CITY OF ALBUQUERQUE

RE: 1401 Wyoming Blvd NE - Maverick
Grading Plan Engineer's Stamp Date: 1/08/2019
Hydrology File: J19D049

**RE: 1401 WYOMING BLVD NE MAVERIK GAS STATION
RESPONSE TO HYDROLOGY COMMENTS DATED 12/10/2018
HYDROLOGY FILE: J19D034**

660-SA OIL WATER SEPARATOR

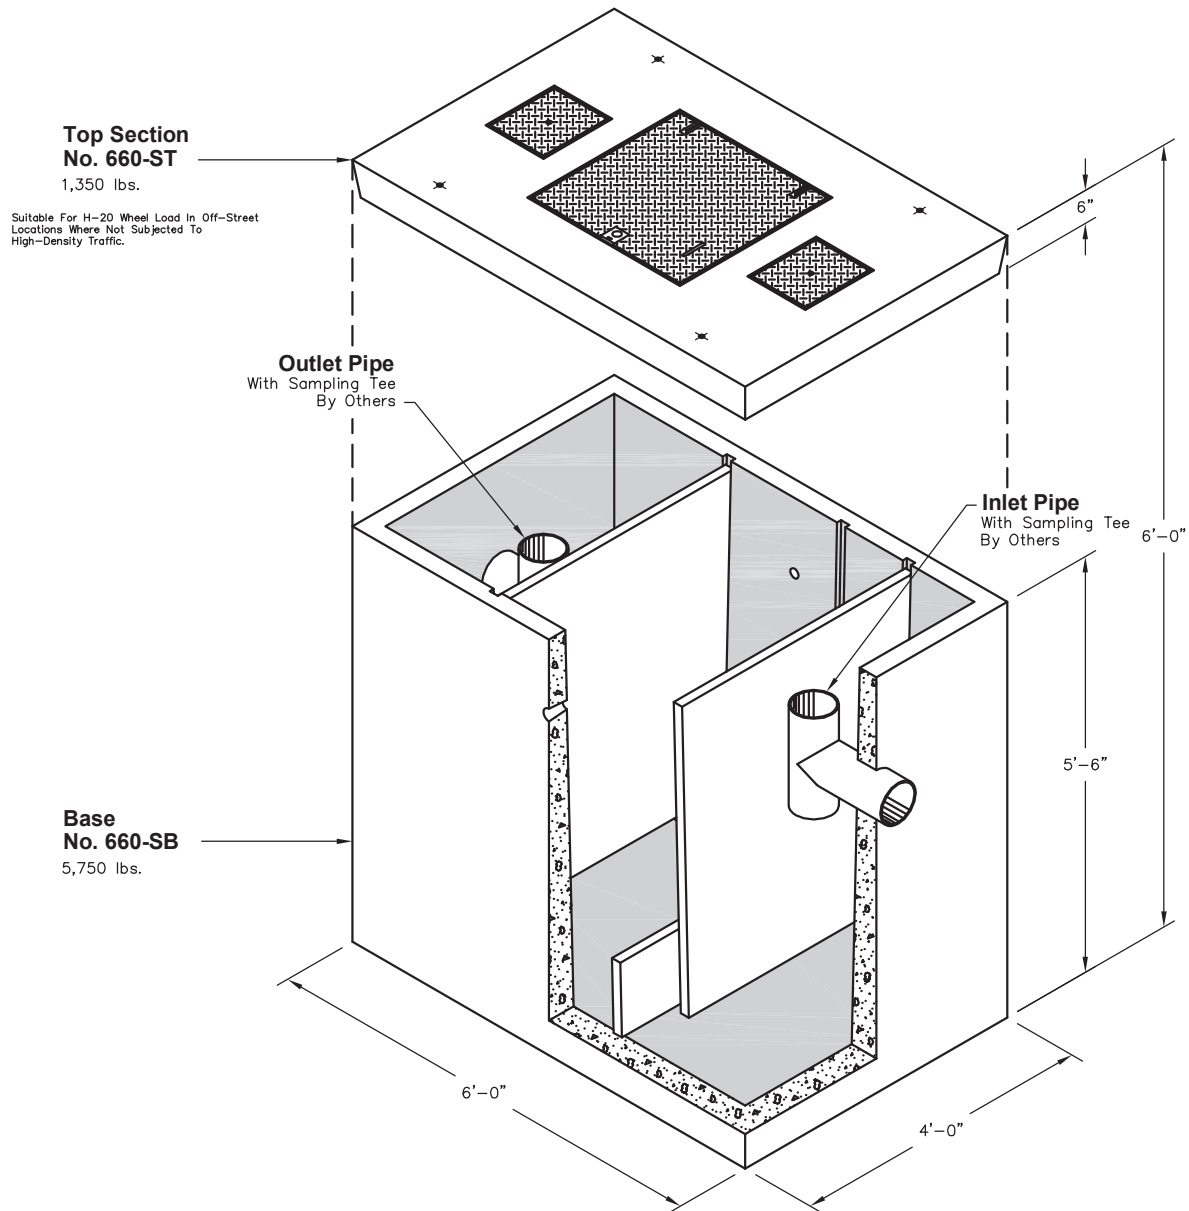
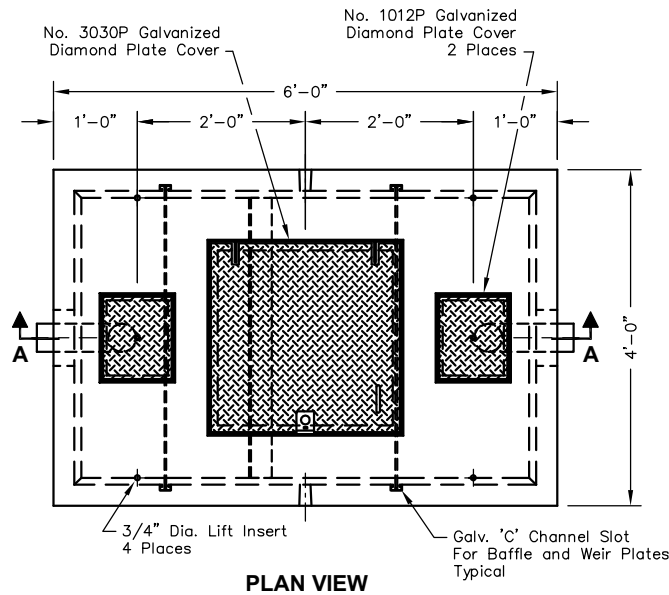
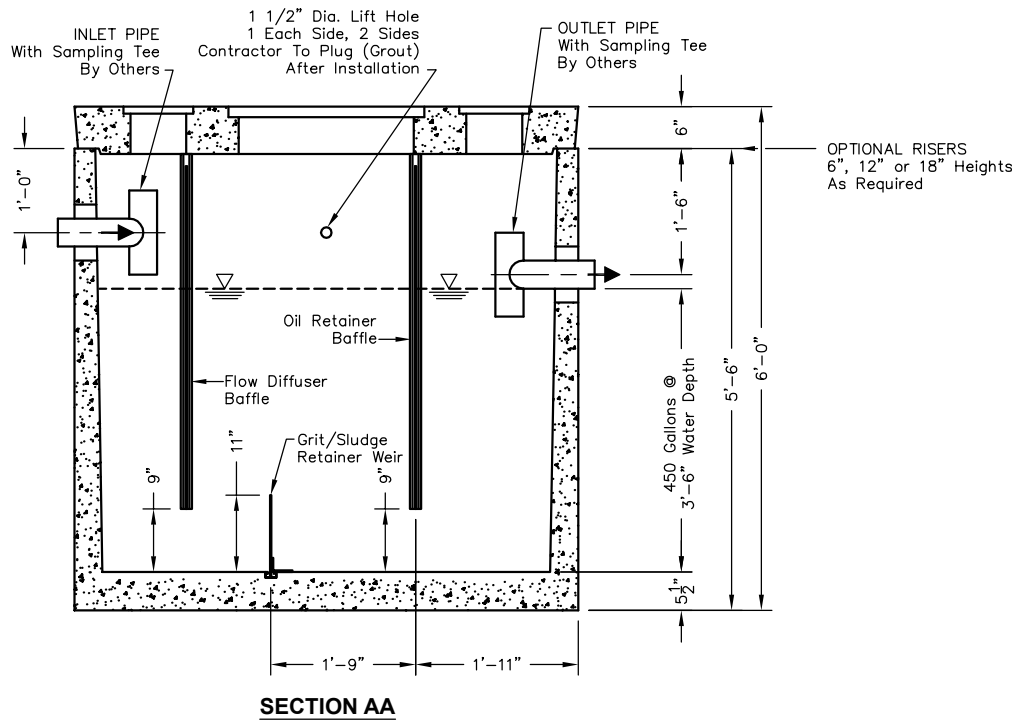
1. The oil/water separator may not discharge into the sanitary sewer. The oil/water separator maintenance should be addressed in the maintenance plan to include routine Vactor cleaning and a manifest of Vactor service with inspection notes. The separator may discharge in a "Drain Line Thru Curb". The drain line should be 4" diameter per DWG 2235.

3. Response:
The oil water separator is required to be connected to the sanitary sewer line due to the grades across the site and the DPM requirement for gas stations to provide treatment for runoff generated across the refueling areas. I have corresponded with Mr. Travis Peacock at the Water Authority and asked for written confirmation this approach is acceptable.

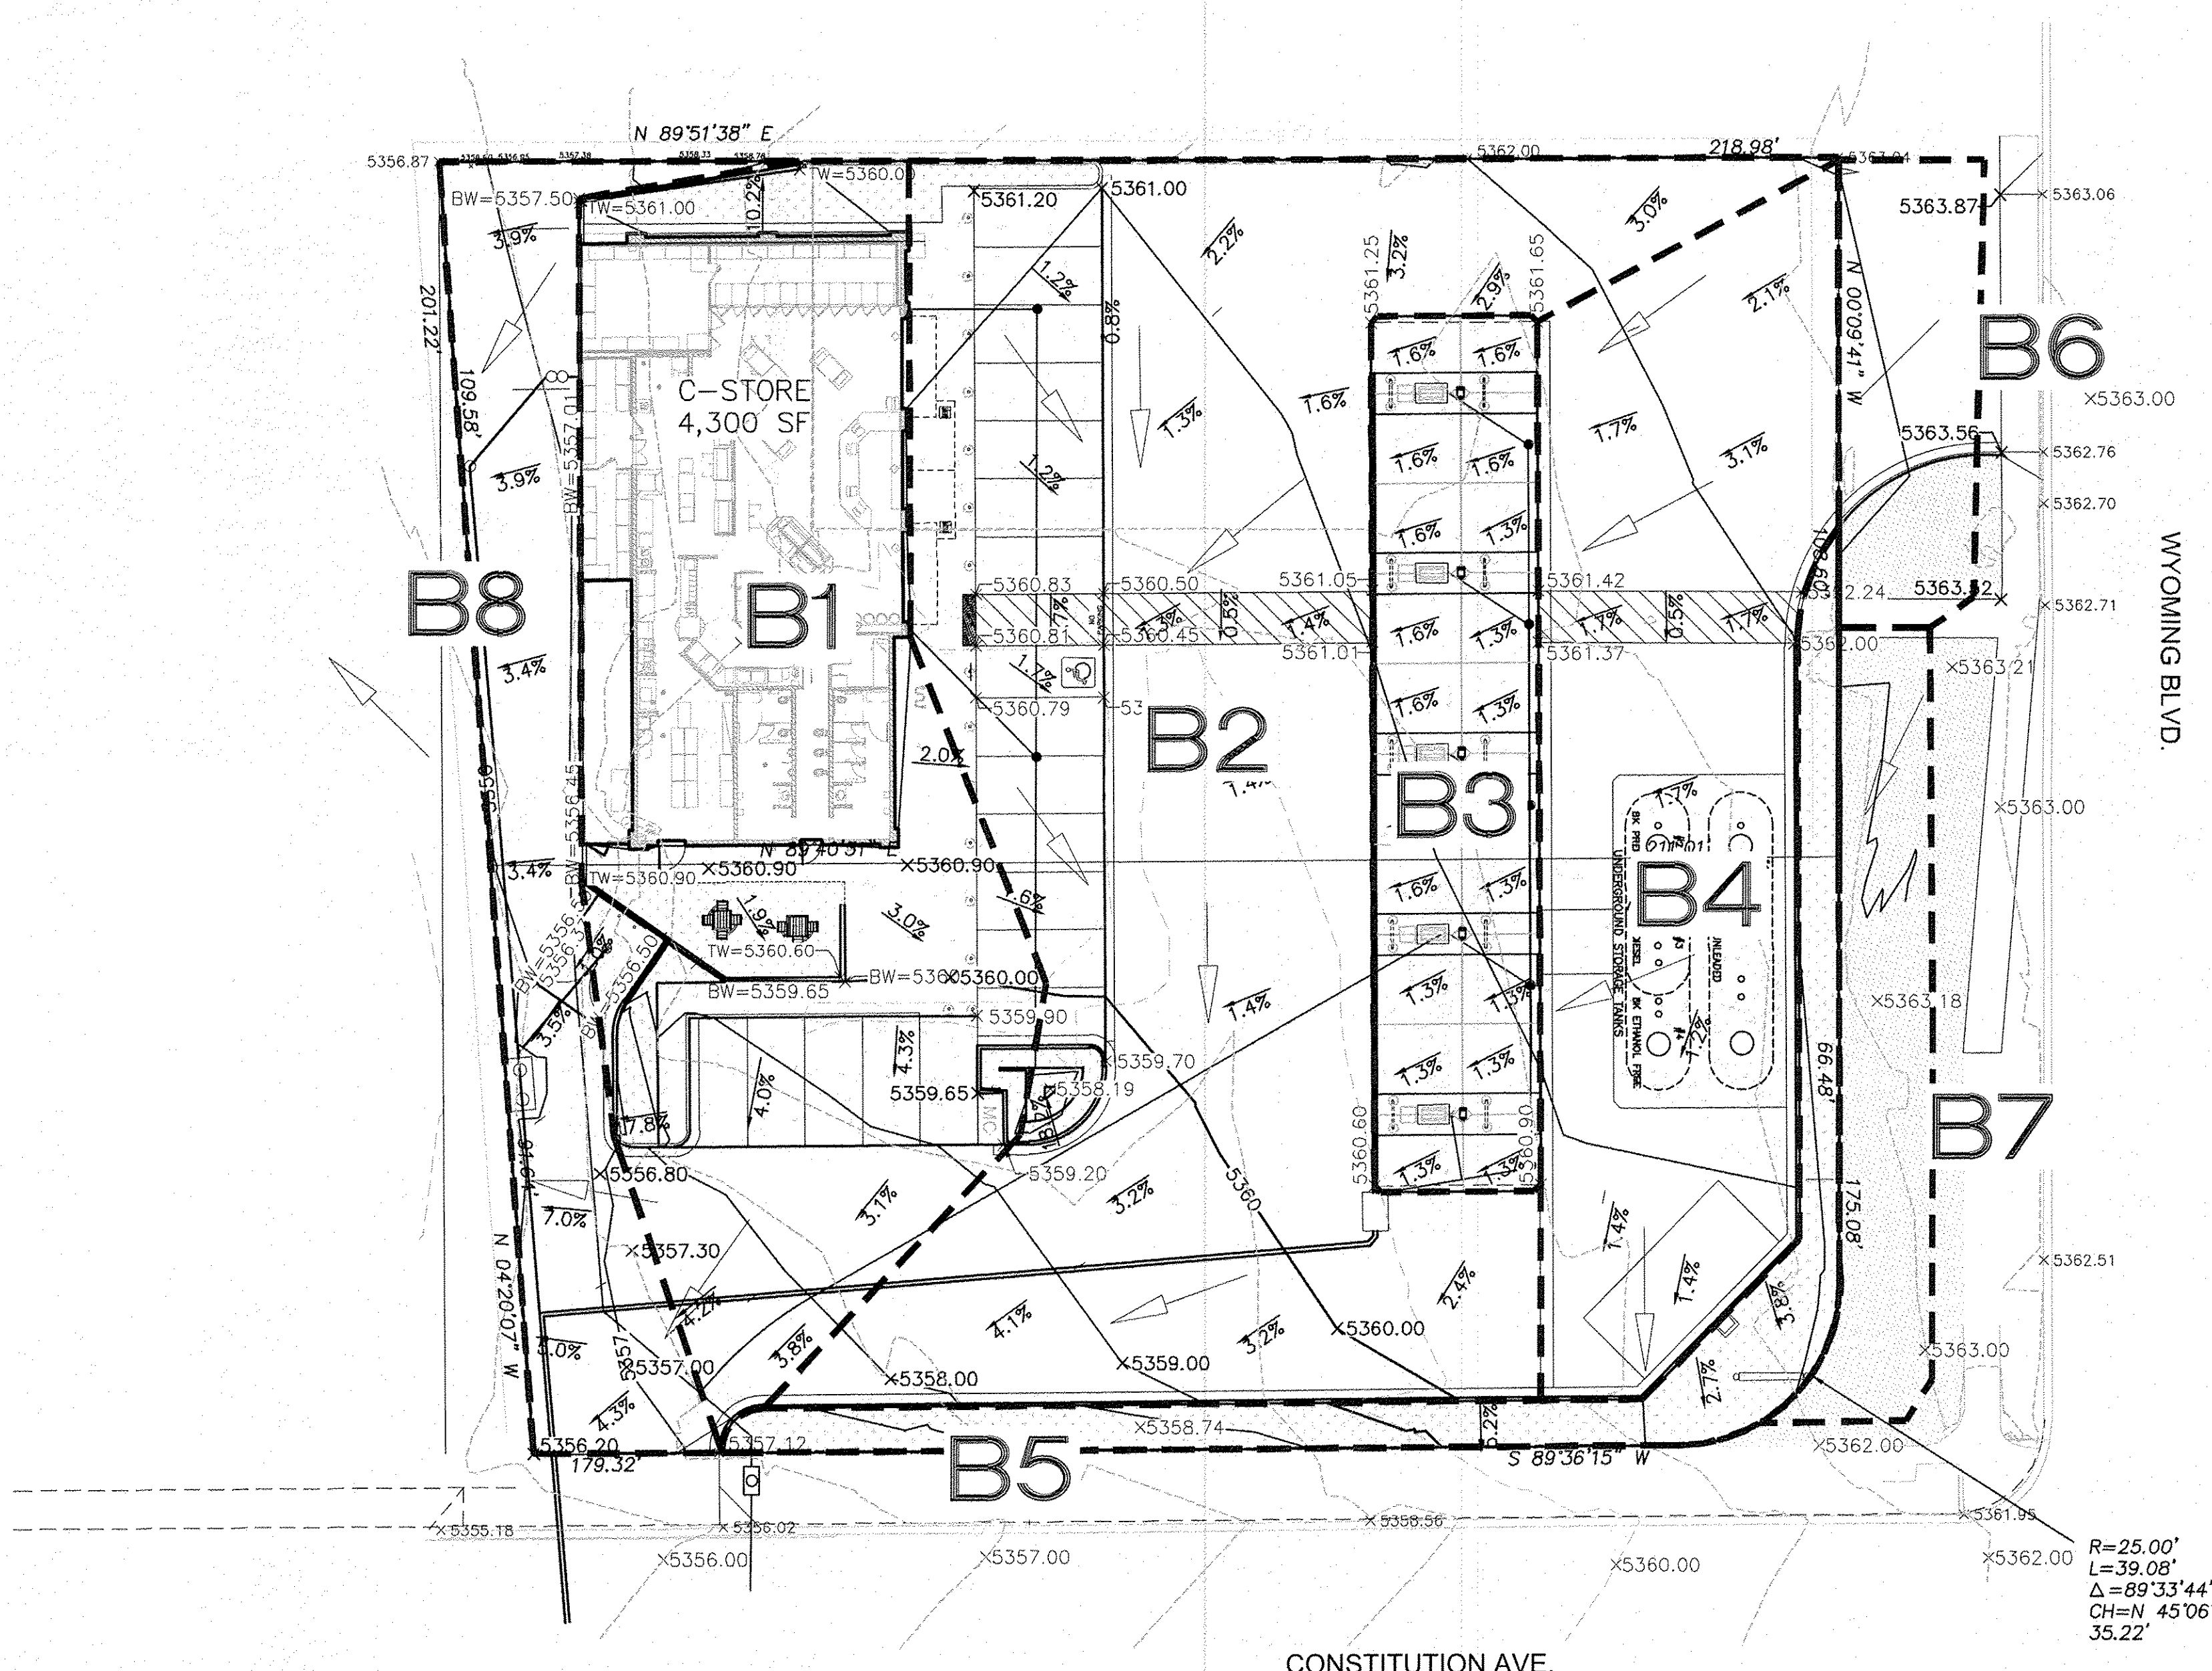
2. Please identify all easements on the G&D Plan with book and page of recorded documents, and provide a copy of the cross lot drainage easement to Hydrology.

3. Please clarify and differentiate pavement "overlay" from areas of "removal and replacement". The entire site is paved now. If the impervious surface is removed and replaced then it is considered redevelopment and is subject to applicable permits. But overlay and/or fog seal is not subject to permits and does not require any SWQV. Please adjust the notes and hatch patterns accordingly.

6. Show all of the work in the adjacent streets on the G&D Plan including removal of the existing driveways and reconstruction of the sidewalk and C&G.

6. Response:
The SWQV pond was removed from the design and replaced with landscaping.
7. Response:
All site easements were added to the grading plan Sheet C2.

8. Response:
The area to the west of the building to be resurfaced will be completed with asphalt to match the existing pavement along the alleyway. The areas to be resurfaced are

labelled and hatched on the grading plan. These areas were not included in the SWQV calculations.
